The American Waterways Operators

Re: AWO Comments on the
Proposed 15-Day Modifications to
the Proposed Regulation Order

Figure 1: Crowley Tug SCR Arrangement

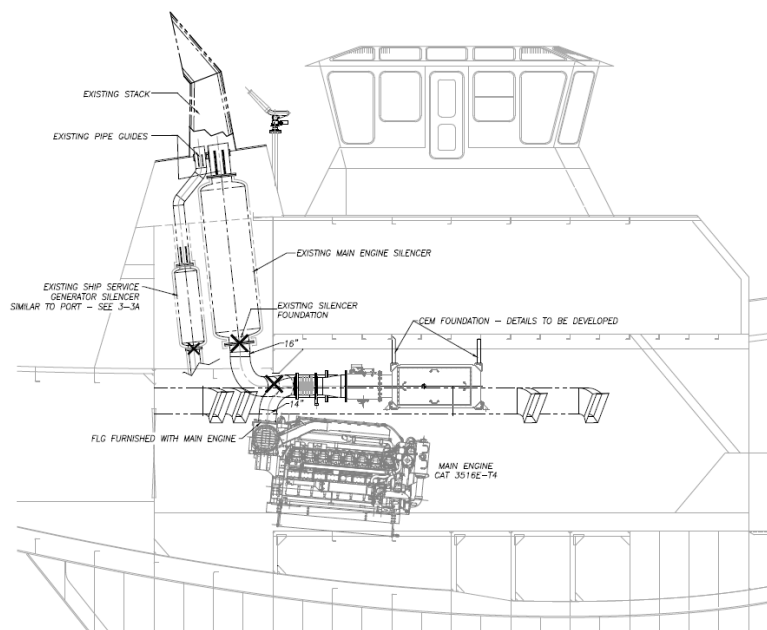
- The tug is fortunate to have the available space in the overhead of the engine room so the SCRs were located above the main engines as shown in Figure 1.

Figure 2: Example of SCR Located in the Stack

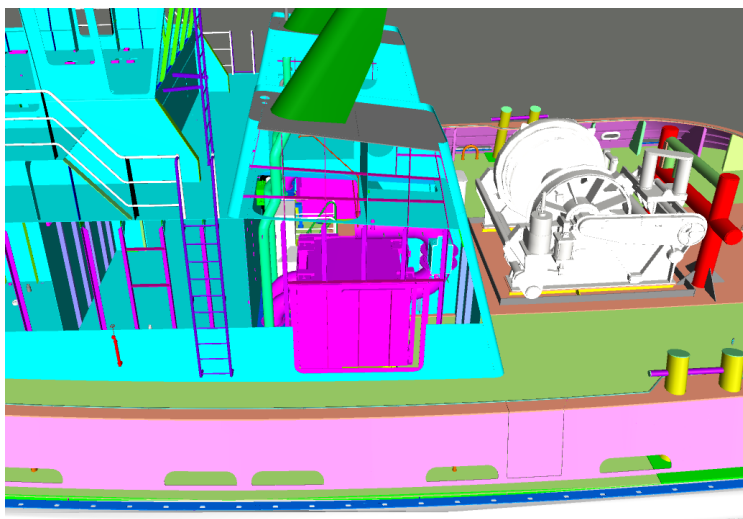
As described above, the engine room of a ship assist and escort tug may not allow for the installation of SCRs in the overhead. In these cases, the SCRs may need to be located in the stacks which requires more extensive structural modifications and typically has an impact on the engine room ventilation fan arrangement. This can also create challenges in accessing the SCR for routine maintenance. Figure 2 shows an example of an SCR located in the stack. Note that this was excerpted from a new design.
